CITY COUNCIL MEMORANDUM

FROM: The Office of the City Manager **DATE:** January 13, 2020
SUBJECT: PP 2019-07 Consideration of a request from MM City Point 53 LLC for a preliminary plat of City Point Addition Phase 2, being 21.55 acres located at 4401 City Point Drive.
PRESENTER: Clayton Comstock, Planning Director

FIGURE 1

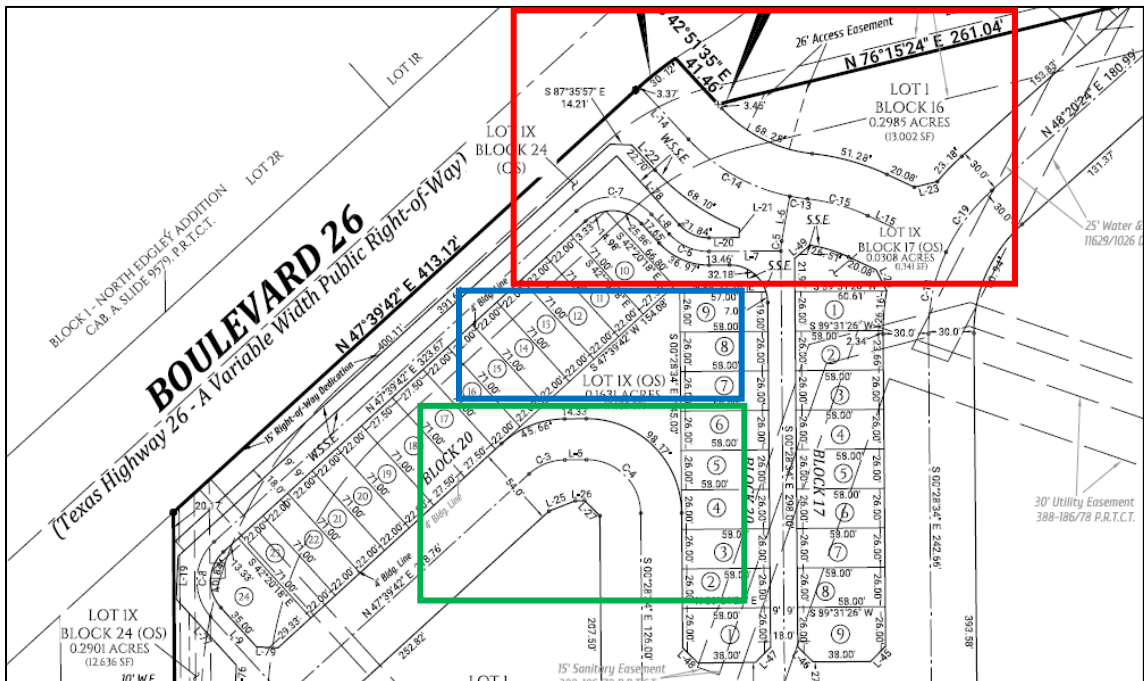
1. A new street entrance from Boulevard 26 is proposed south of the Takara restaurant at the corner of City Point Drive. This new street is approximately 300 feet long and provides a connection from Boulevard 26 to the ring road around the development. At about the midpoint on this street, two alleys merge and intersect the new street (see red box in Figure 1). The configuration of this intersection poses several challenges related to traffic safety, engineering design, and emergency services.

The Development Review Committee has concerns about this confluence of multiple streets and alleys within such close proximity to Boulevard 26. This alignment could prove problematic if vehicles, including waste collection trucks, cannot maneuver safely through the acute angles of this intersection.

2. The design of the street connection also results in 11 lots fronting an open space lot. Since these lots do not have frontage on a public street, the delivery of emergency services to the lots becomes complicated. Utilities such as water and sewer would be located in the small area of the acute-angled open space making

it difficult for public works to access this infrastructure and significantly limiting any tree planting opportunities within the open space (see blue box in Figure 1).

3. The acute angle in the proposed street at the north end of the open space is too tight for emergency service vehicles and will require revision as the project is further engineered (see green box in Figure 1).
4. While the proposed preliminary plat is reflective of the concept plan approved as part of planned development zoning, it was clear that the concept plan was also illustrative and not binding. All exhibits approved by the PD state, “the alignments, park/open spaces and trails are illustrative in nature and may change due to final surveys, field conditions, and environmental findings, utilities, final site plans, and City of North Richland Hills and other governmental agency reviews and approvals.”

The Development Review Committee recommends the applicant reevaluate the alignment of streets and blocks on the southern portion of this plat to orient homes toward Ruth Road for street activation, pedestrian orientation, and better internal access to open space.

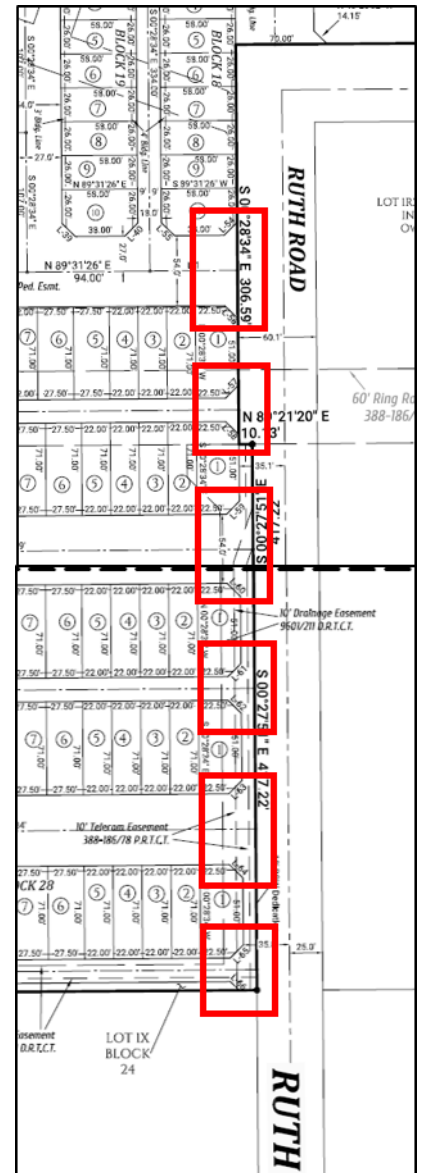
The concern is that the proposed block alignment along Ruth Road does not support the creation of high-quality street and sidewalk environments that are supportive of pedestrian mobility, and is not oriented towards the pedestrian realm to enhance and activate streetscapes. Specifically, six alley and street intersections break up Ruth Road within a 600-foot stretch (see inset diagram highlighting the alley and street intersections onto Ruth Road). This creates multiple street and alley crossings for pedestrians and limits the amount of on-street parking and street trees. By siding the homes to Ruth Road, there are also no front doors to activate the street and balance the streetscaping already established on the east side of the street with the multi-family project currently

under construction. Furthermore, the southernmost two streets of the proposed preliminary plat separate this area from the open space further to the north. Residents would be required to walk along this pedestrian-unfriendly Ruth Road to come back into the site to access the open space. Open spaces should be easy to access within an Urban Village style of development.
